Product Change Notice (PCN)

PCN Number: PCN-0450952R-01

Product(s) Affected: PJ-025

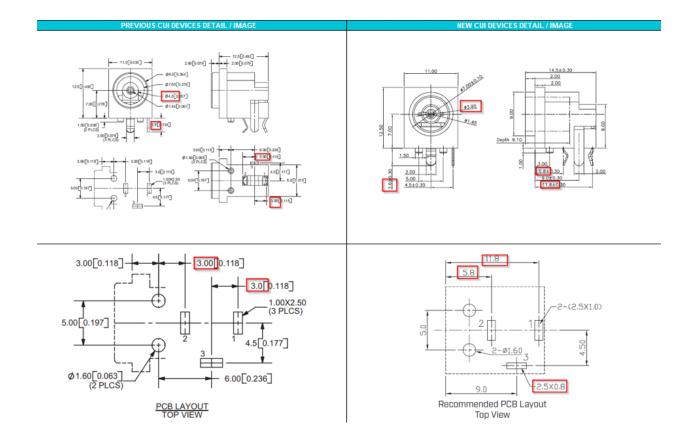
Description of Change: Minor Housing and footprint differences. Material Change on the

housing and terminals. See image Below

MATERIAL	PLATING
center pin	brass	tin
terminal 1	brass	tin
terminal 2	copper alloy	tin
terminal 3	brass	tin
plastic	PBT

DESCRIPTION	MATERIAL	PLATING/COLOR
terminal 1	bronze t=0.50	silver
terminal 2	bronze t=0.25	silver
terminal 3	brass t=0.40	silver
Insulator	PA66 (UL94V-0)	black
